Re: Finance Docket No. 34658, The Alaska Railroad Corp. -- Petition For Exemption From 49 U.S.C. §10901 To Construct and Operate a Rail Line Between North Pole, Alaska and Delta Junction

The Alaska Railroad Corporation's ("ARRC") provides this response to the concerns raised by the Alaska Department of Fish and Game ("ADF&G") regarding ARRC's proposed river training and channel modifications for the Tanana River crossing at Flag Hill and how they might affect salmon spawning areas (fish locations 52479, 52480, 52461 as provided by ADF&G, July 2008, Figure 1). As part of this response, ARRC is including a revised conceptual bridge design.

TANANA RIVER CROSSING CONCEPT
 FLAG HILL

Figure 5

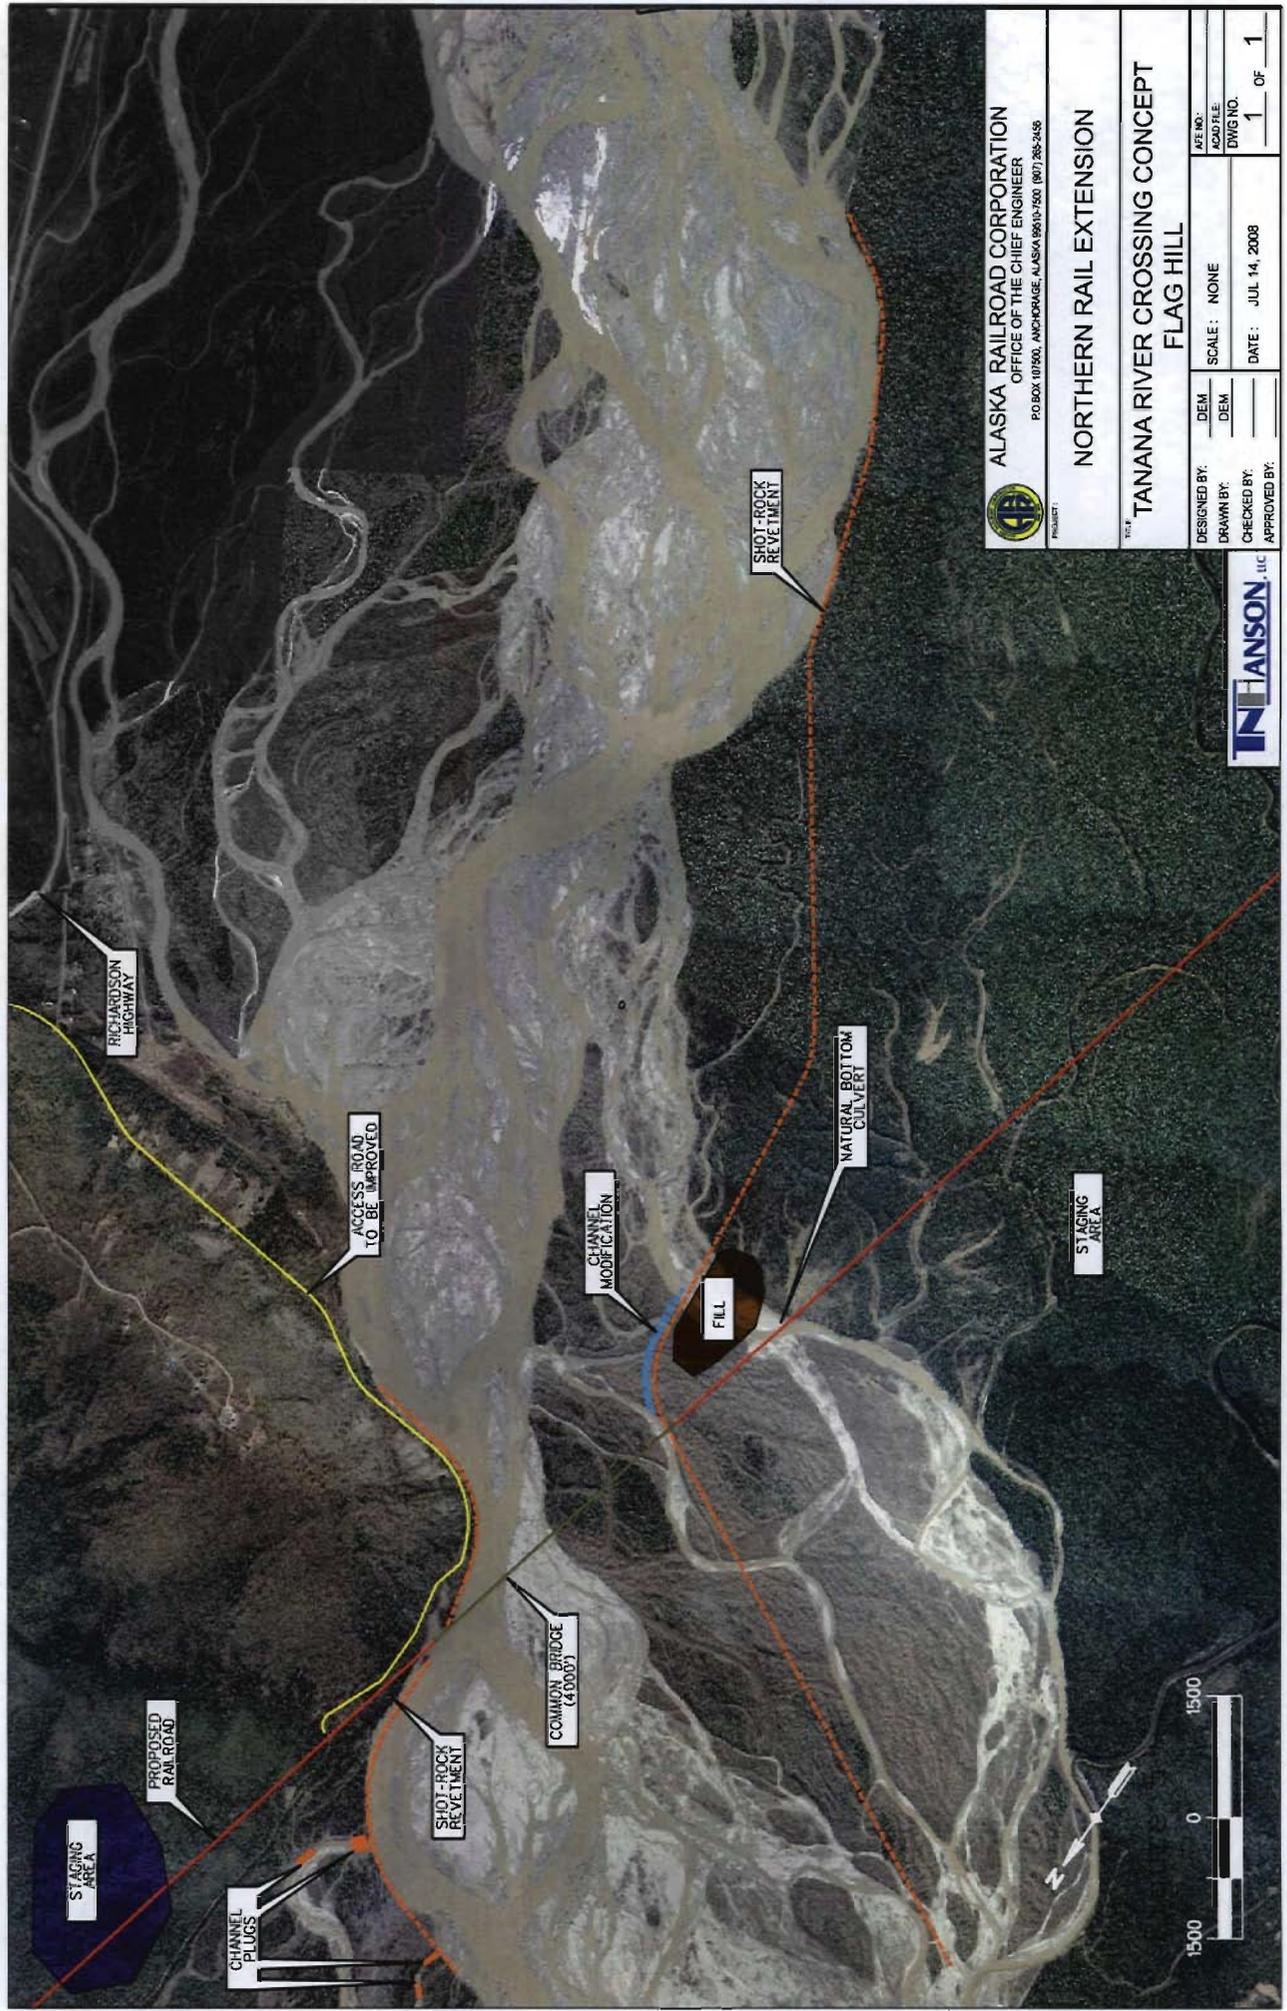
To address ADF&G's concerns, ARRC has revised and refined its most recent Flag Hill concept (Figure 5) to limit the in-water work in the spawning areas of concern. The bank-hardening revetments have been moved off the existing bank inland, and then wrap around the south abutment face. The south channel is then re-directed into the center channel downstream of the spawning area. The material sourcing area has been removed, and the clear-water channel outfalls downstream of the crossing would be un-impeded in their connections to the Tanana River. These revisions provide the most reasonable and practicable means to cross the Tanana River at this location. ARRC supports this approach as a preferred option to address ADF&G's concern relating to the spawning habitat.
